SEMINOLE COUNTY, FLORIDA

Development Review Committee

Meeting Agenda

**9:00AM (TEAMS) ALLURE RESIDENTIAL - COMMERCIAL -
PRE-APPLICATION**

DRAWN
CONTRACT DATE 11/17/23
SCALE AS SHOWN
JOB NO. 2232.PRJ
SHEET TITLE:
CONCEPTUAL SITE PLAN
SHEET NUMBER:
SP-1

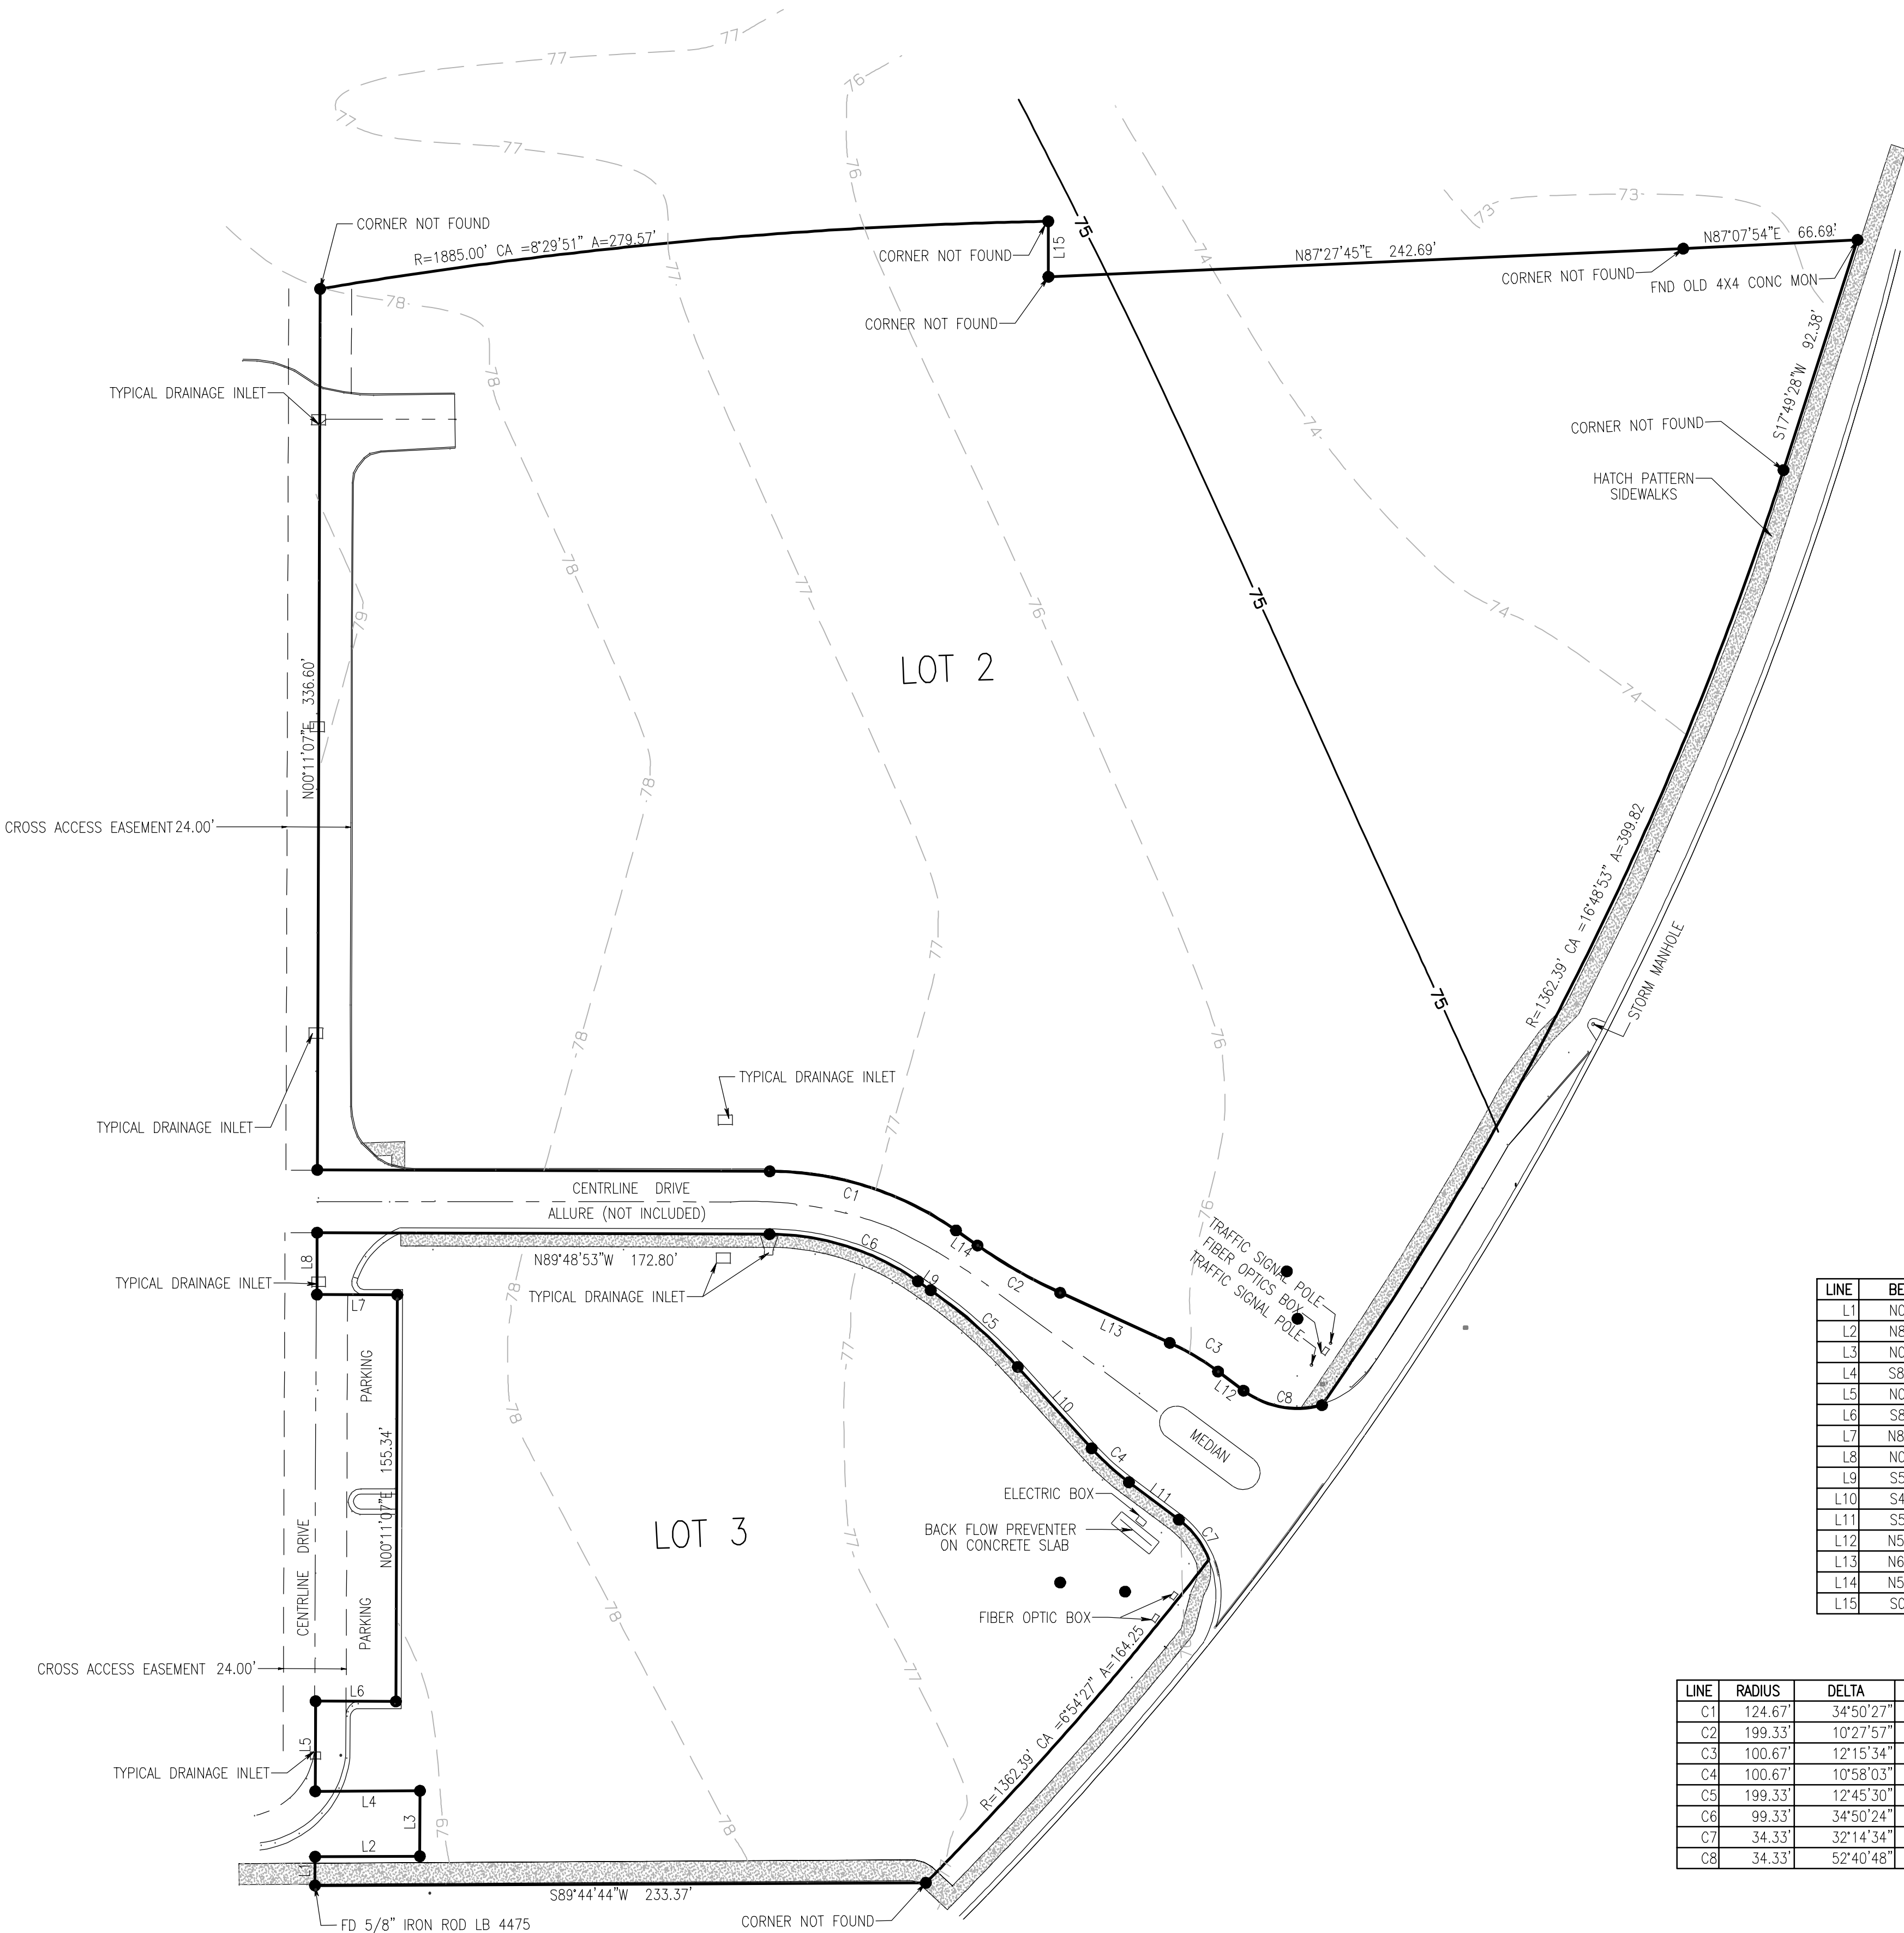
10.	Building Division	The application states scope of work as 195,000 sf. PEMB. The plans show apartments retail and a restaurant.	Info Only
11.	Comprehensive Planning	This project has an approved Development Order with approved uses that are consistent with the uses proposed in this pre-application.	Info Only
